MEMORANDUM

DATE:	February 12, 2021	RWDI REFERENCE #: 1904405
TO:	Anthony Witherdin	Director, Key Sites Assessments - DPIE
FROM:	Kevin Peddie	Email: kevin.peddie@rwdi.com
	Michael Pieterse	michael.pieterse@rwdi.com
RE:	ADG Natural Cross Ventilation- City of Sydney Review Response Waterloo Metro Quarter – Building 4

**Image 1: Potential Natural Cross Ventilation Flow Paths
 One Approach noted in the ADG (Left), Proposed Floor Plan (Right)**

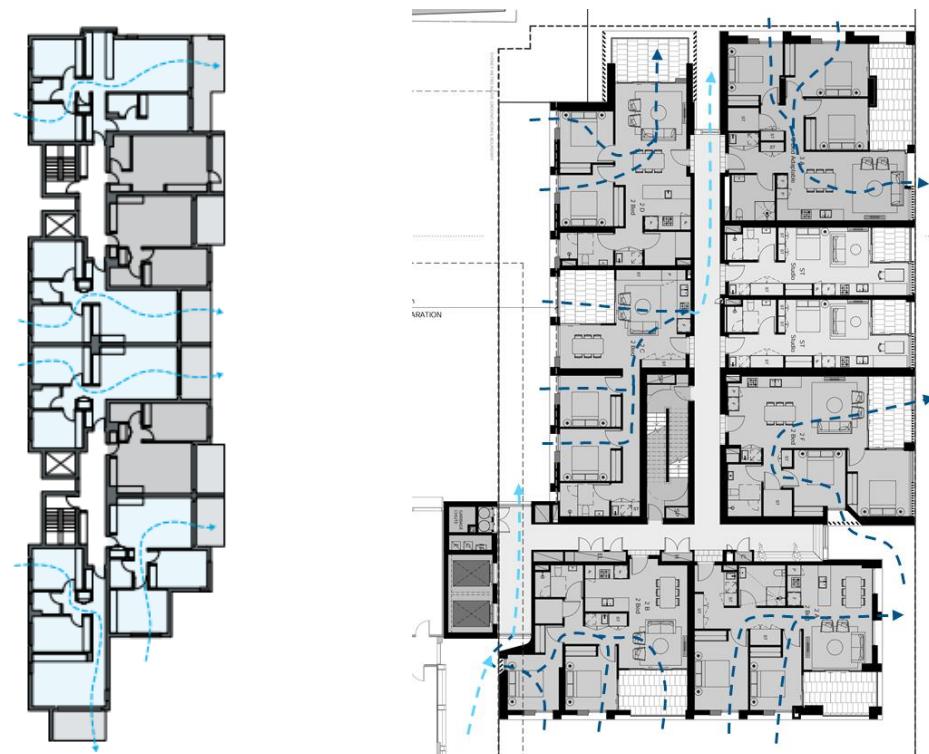
Item 28 - Natural cross ventilation -The application erroneously claims that 60% of apartments are designed to achieve natural cross ventilation, however only 34% of apartments meet the definition of naturally cross ventilated. For example:

- *Plenums must not be used to claim natural cross ventilation as they do not provide equal sized outlets for pressure-based airflows.*
- *Corner apartments that do not have opposite openings of equal size and do not provide a logical flow path of air should not be counted.*
- *Natural ventilation paths should not cross common circulation spaces.*

The apartments considered to be naturally cross ventilated in accordance with the Apartment Design Guide for the Building 4 design. The tower design includes a setback to the south-eastern corner apartment on the eastern aspect to create a stepped form and enable exposure to the prevailing winds in accordance with the ADG requirements for Natural Cross Ventilation.

Figure 4B.8 of the ADG (noted in Image 1 below) indicates *one approach* for how natural cross ventilation can be achieved. The design guidance for this simply notes that "The building should include dual aspect apartments.....". Dual aspect apartments are noted in the Glossary of the ADG as cross ventilating the apartment which have at least two major external walls facing different directions. These examples and definitions align with the current design of Building 4 which comprises of a stepped form in plan at the south-eastern corner, enabling unimpeded dual aspect openings to the apartment.

As noted in the Response to Submission document prepared by the project architect, Building 4 was required to balance a number of aspects including the apartment mix brief from the LAHC, maximising the solar access to the residential apartments and minimising apartments with no access to sunlight. The floor plan layout was also limited by its location atop the metro station services box, the need to naturally ventilate the corridor space while also considering apartment entrance door operability issues due to pressure differential between the corridor and apartment window openings.
